TWO-DIMENSIONAL HYDRAULIC MODELING OF RIPARIAN HABITAT
RESTORATION FROM COLUSA TO PRINCETON

SACRAMENTO RIVER, RM 142.5 TO RM 164.5
GLENN AND COLUSA COUNTIES, CA

**Appendix O -
Review Comments to Report with Responses by
Ayres Associates**

Colusa Planning Subreach Project, Colusa to Hamilton City 2-Dimensional Hydraulic Model, Response to Comments from:

Figure 1: (a) Existing Conditions (Without Project) and (b) Restored Conditions (With Project) Land Use in the vicinity of Ward Tract, as represented in the model. (adapted from Ayres Associates)

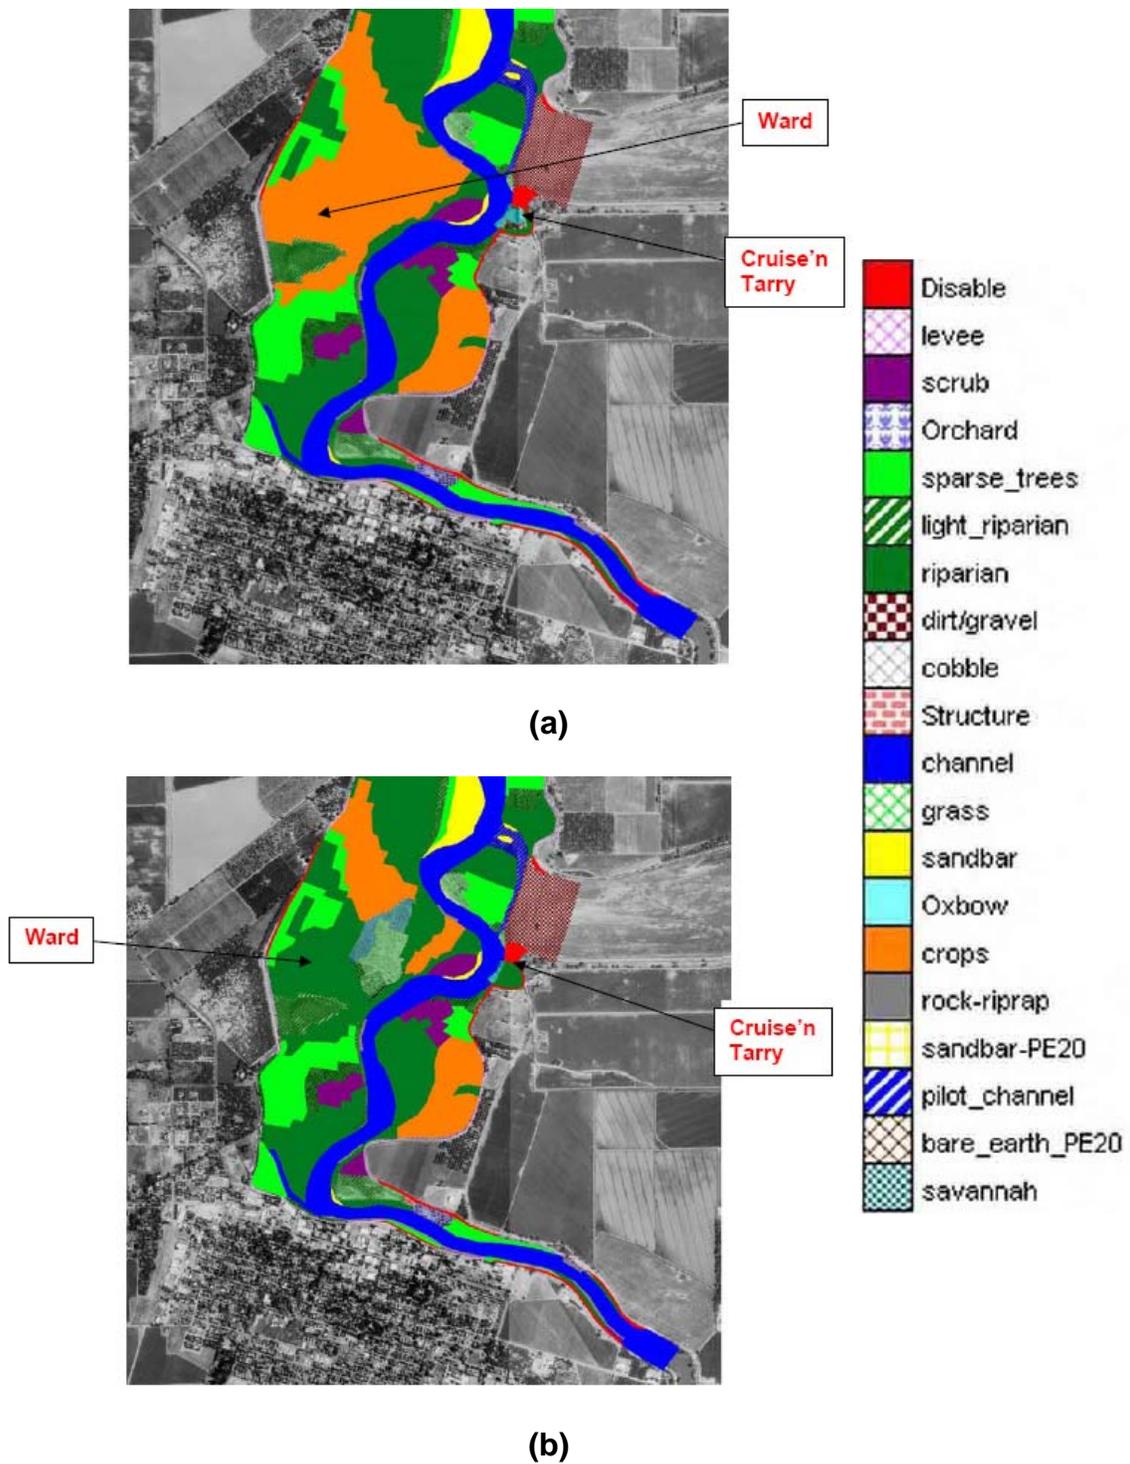
- In the restored conditions (with project) run, the Ward Tract restoration area was represented as being in a mix of vegetation types: grassland ($n = 0.032$), savannah ($n = 0.045$), and riparian forest ($n = 0.090$). (See **Figure 1 b and Figure 2**).

Figure 3: Comparison of Modeled Water Surface Profile with High Water Marks on the East Bank. (Ayres Associates) Note that model calibration trends at or slightly above the measured high water marks at most locations, including the vicinity of Ward Tract (RM 145 to RM 146)

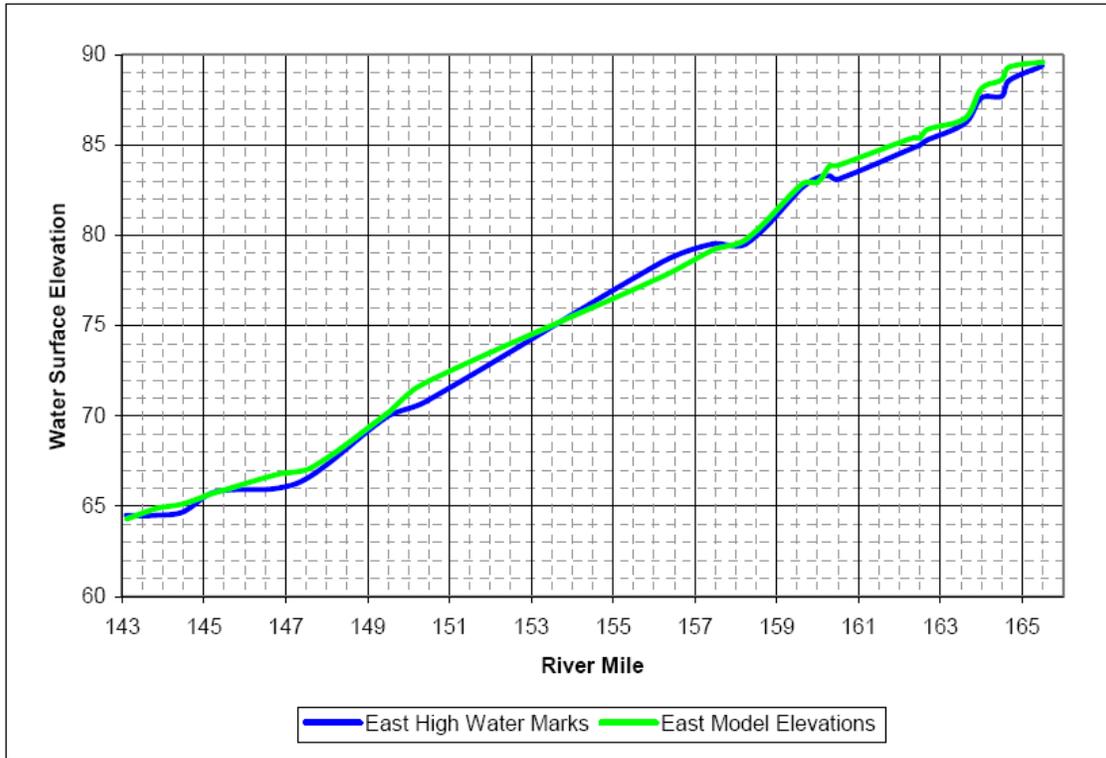
- The model calibration trends at or slightly above the measured high water marks, at most locations, especially along the downstream half of the model, where the Ward Tract is located. (See **Figure 3**) Ward Tract is located between River Miles 145 and 146. The calibration of the model trending at or slightly above the measured high water marks is both conservative, and an indication that raising hydraulic roughness values would reduce the closeness of fit of the model calibration.

Figure 7: Difference between Design Profile and Existing Conditions (Without Project) modeled water surface elevations (Ayres Associates)

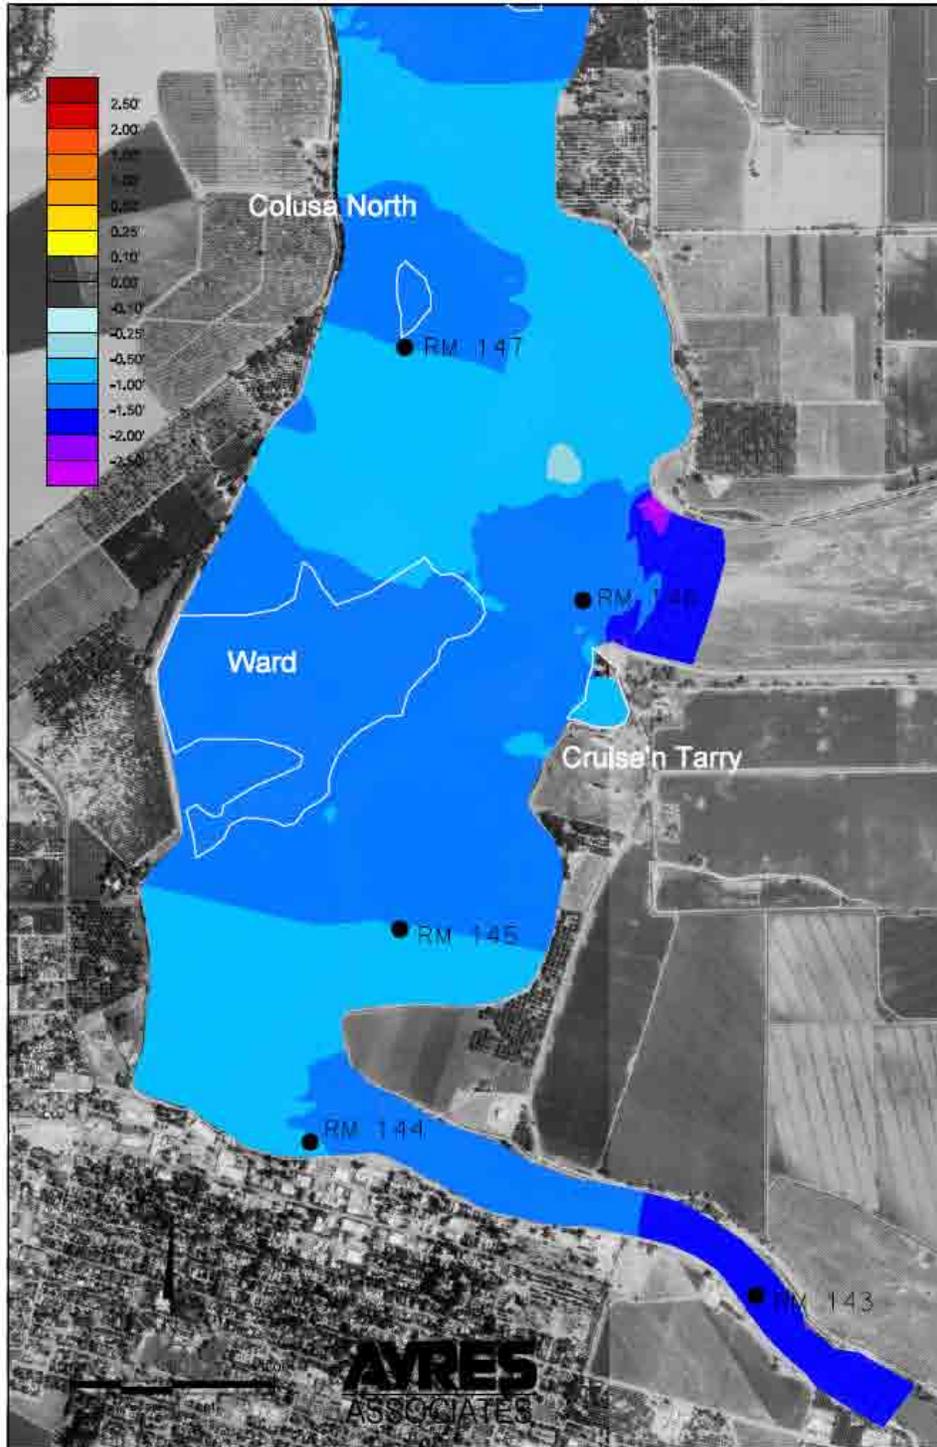
- Model results indicate that for eight river miles upstream of the Ward Tract property, and three river miles downstream of it, under existing vegetation conditions, when 160,000 cfs enters the Colusa Subreach, the water surface ranges from 0.25 to 3 feet below the design profile. (See **Figure 7** to view River Miles 144 through 147, and Ayres' report for graphics of more distant sites). In the immediate vicinity of Ward Tract, the water surface ranges from -0.5 to -1.5 feet below the design profile. Note that the design profile itself is at least 3 ft below the levee crest.

Figure 8: Difference between Design Profile and Restored (With Project) modeled water surface elevations (Ayres Associates)

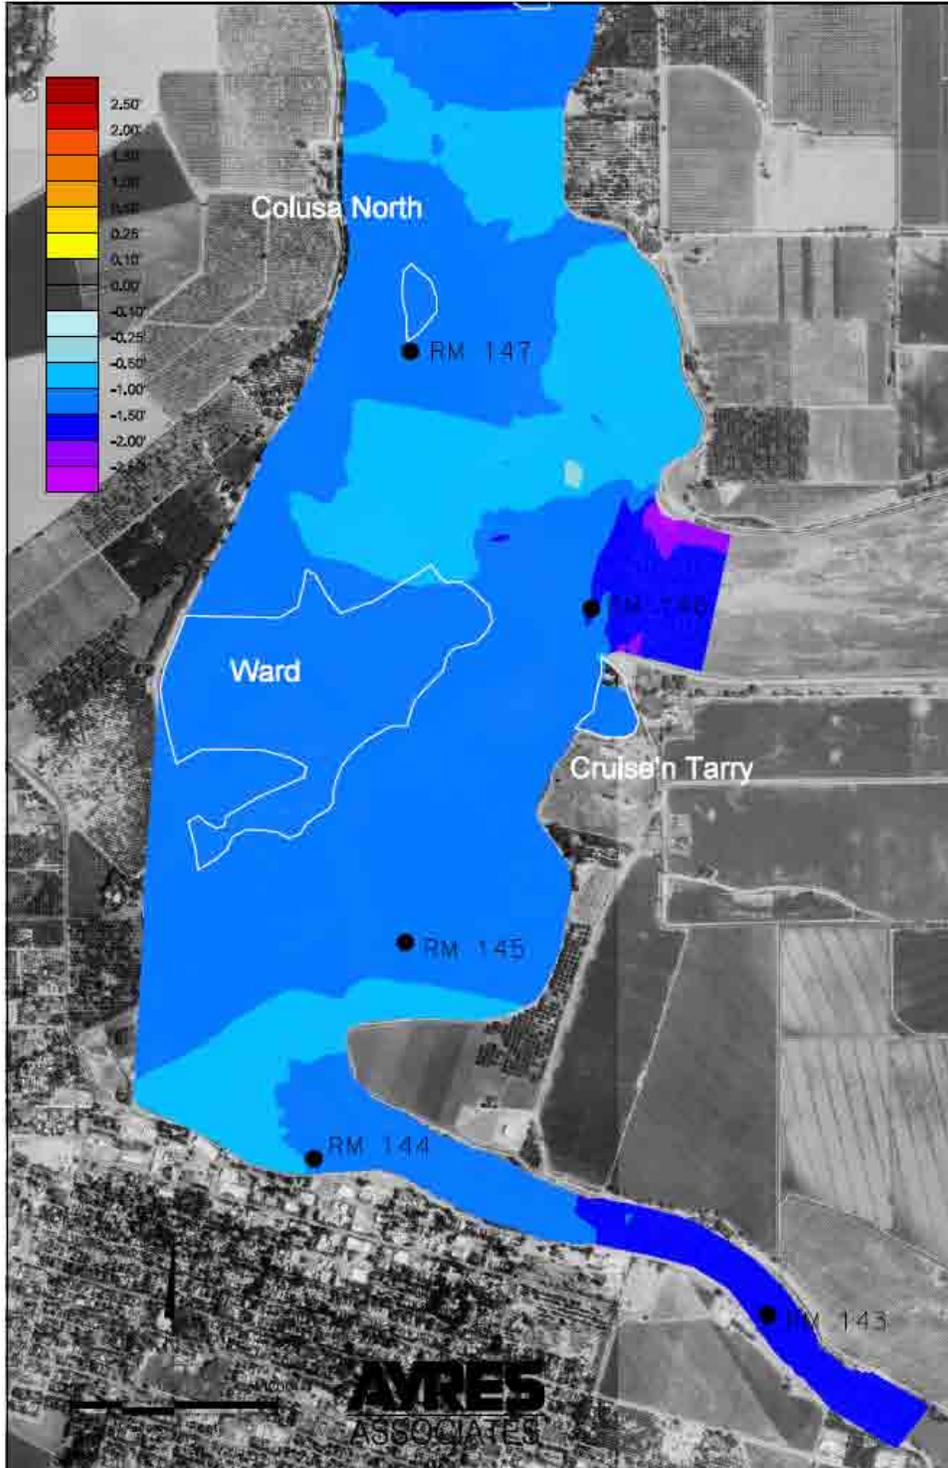
- With the project's proposed restored vegetation conditions, the water surface remains 0.25 to 3 feet below the design profile (See **Figure 8**). There are some slight localized water surface differences (both positive and negative) compared to modeled existing conditions (Compare **Figure 7** and **Figure 8**)

Figure 9: Net change in Water Surface Elevation; Difference between modeled Existing Conditions (Without Project) and Restored (With Project) water surface elevations (Ayres Associates)

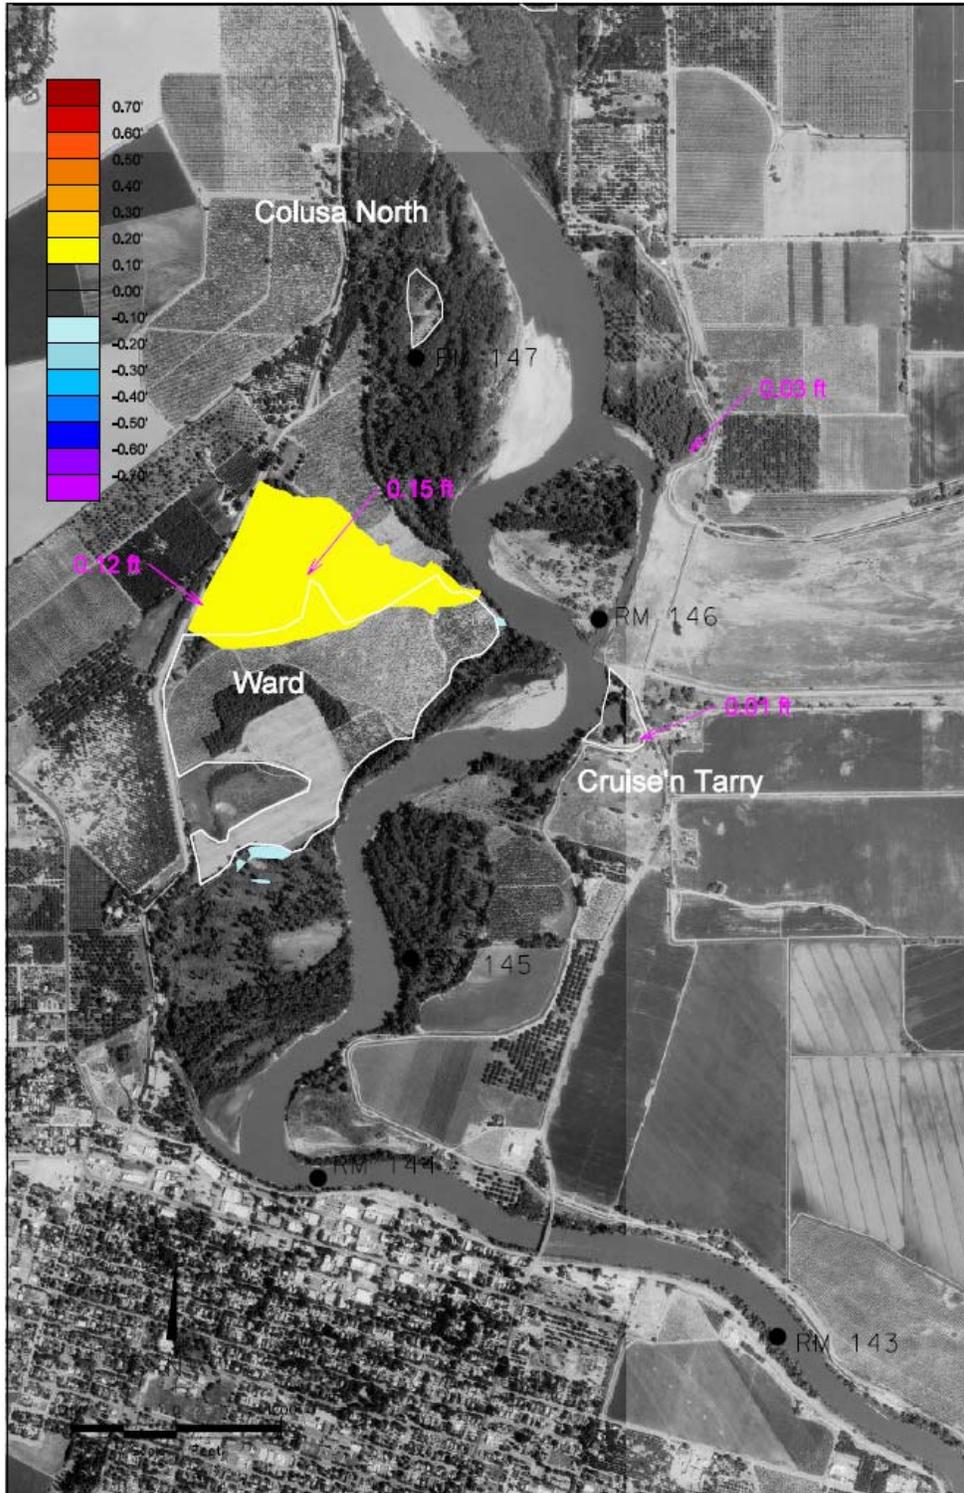
- **Figure 9** isolates the difference between existing conditions and restored vegetation conditions. The yellow triangle indicates the area upstream of Ward Tract where there would be an approximately 0.1 ft rise in water surface elevation. The maximum rise in water surface elevation along the west levee is 0.12 ft. The maximum rise in water surface elevation within the yellow triangle shown is 0.15 ft. The maximum rise in water surface elevation along the eastern levee, north and south of the Colusa Bypass is 0.03 and 0.01 ft respectively.
